**REMEDIATION SYSTEM EVALUATION**

**HELLERTOWN MANUFACTURING COMPANY SUPERFUND SITE**  
**HELLERTOWN, PENNSYLVANIA**

Report of the Remediation System Evaluation,  
Site Visit Conducted at the Hellertown Manufacturing Superfund Site  
June 5, 2001

Final Report Submitted to Region 3  
November 14, 2001

**FIGURE 1-1. SITE LAYOUT SHOWING THE LOCATIONS OF THE MONITORING WELLS AND THE EXTRACTION WELL.**

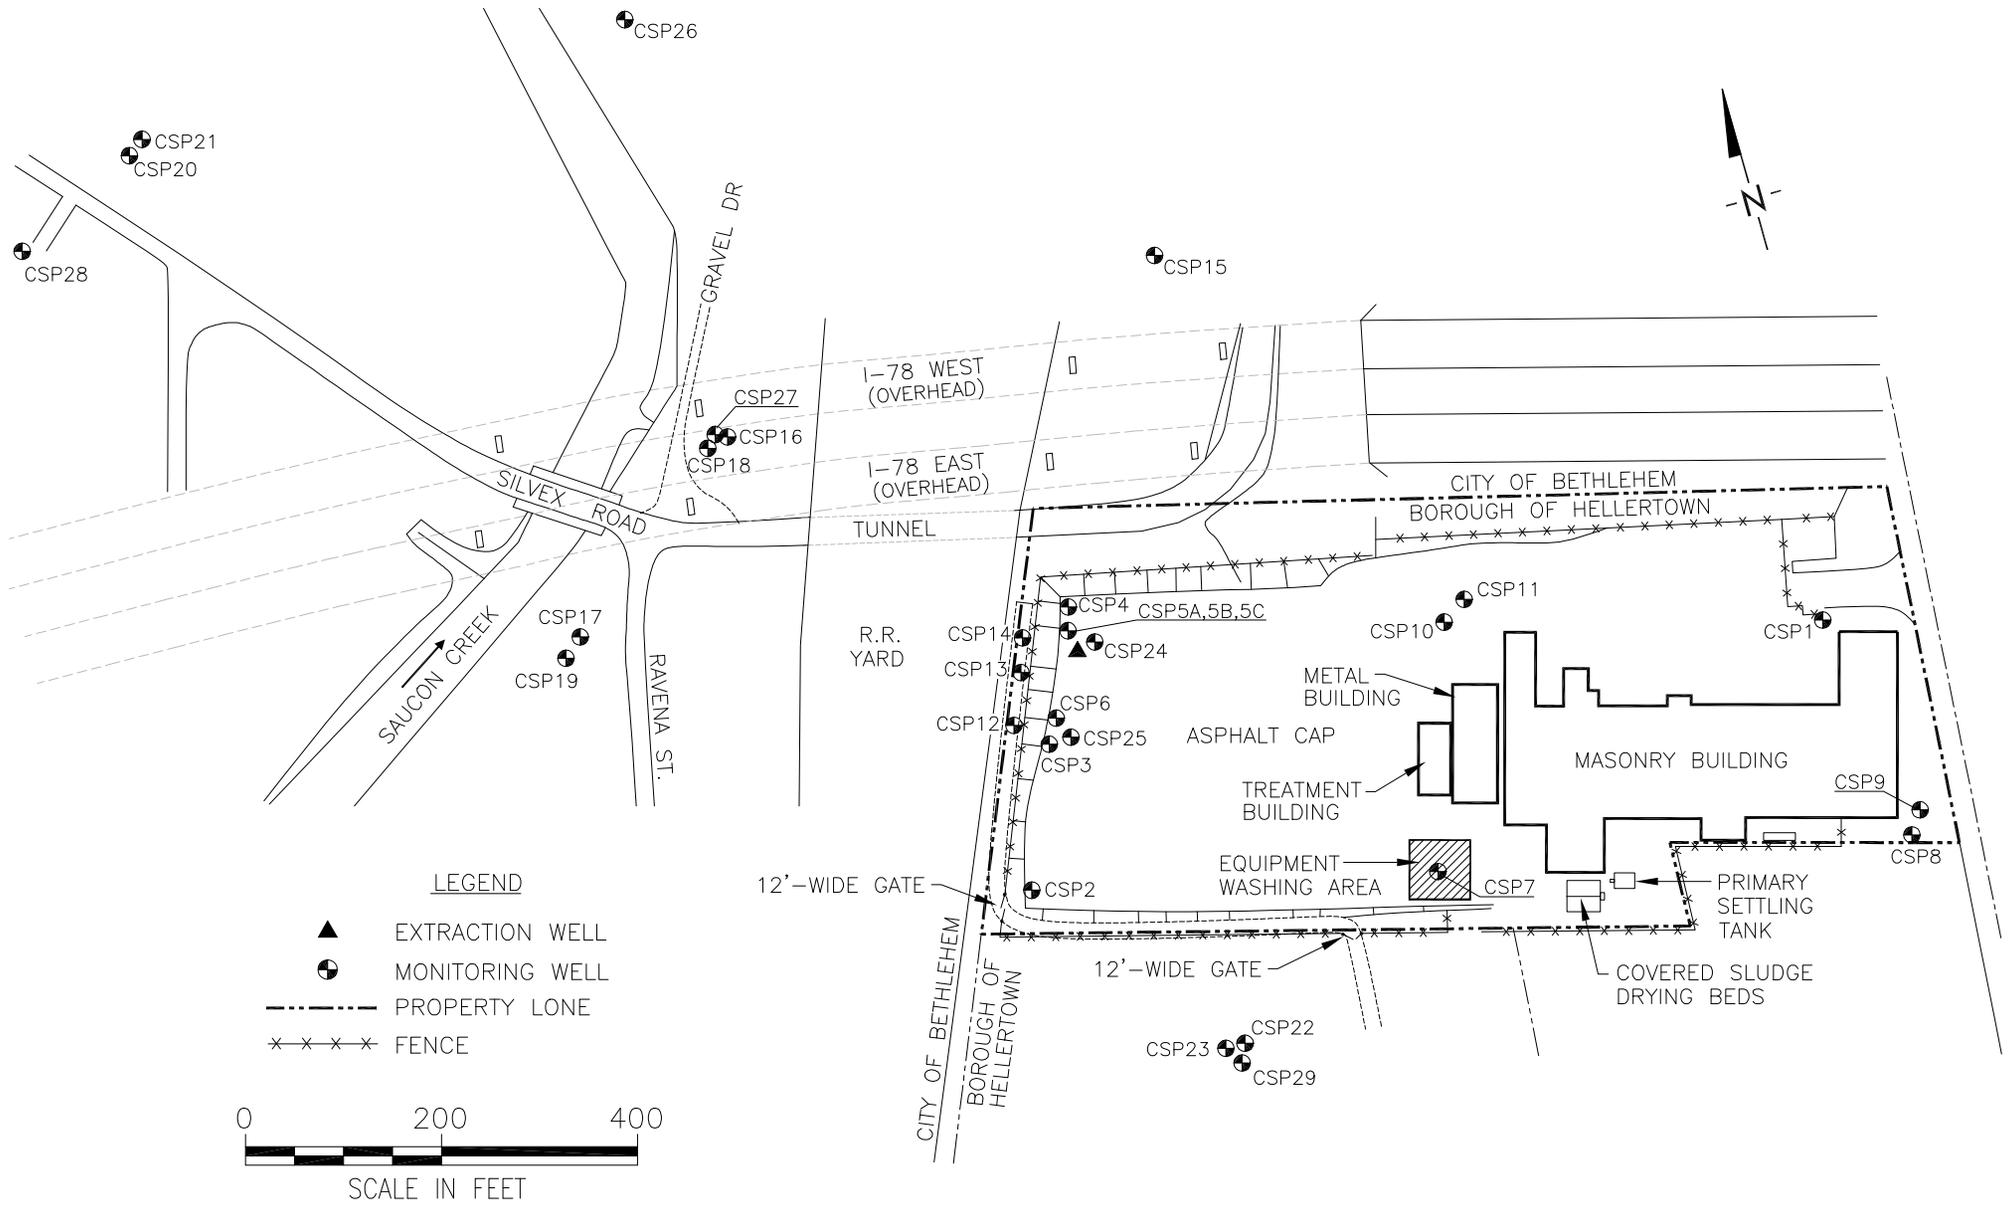
The November 2000 water levels provide sufficient information from the shallow bedrock wells to suggest that groundwater in the shallow bedrock near wells CSP-12, CSP-13, CSP-14, and CSP-5A is captured by the extraction well. Data is too sparse to estimate groundwater directions and capture in the overburden and the deep bedrock or in the shallow bedrock further from the extraction well. Because no monitoring wells or water-level measurements exist for over 400 feet to the west (downgradient) the extent of contamination and capture is unknown downgradient of CSP-12, CSP-13, CSP-14, and CSP-5A.

As stated in the five year review, the capture zone (EW-1R) needs to be further evaluated to determine if EW-1R is containing the entire plume as designed. This should include development of potentiometric surface maps with water levels indicated and interpreted capture zone superimposed. A one-time effort of \$5,000 is appropriate, plus an additional \$3,000 per year thereafter for continued capture zone evaluation on the basis of potentiometric surface maps.

Ideally, one or more monitoring wells in the shallow bedrock should be added between CSP-14 and Saucon Creek, to allow increased resolution for water level evaluation as well as water quality evaluation. The ability to add one or more wells in that area may be hampered by access issues, as well as limitations due to steep slopes immediately west of CSP-14. To add one well should cost approximately \$20,000 in capital costs, and additional sampling and analysis of that well will be less than \$2,000 per year.
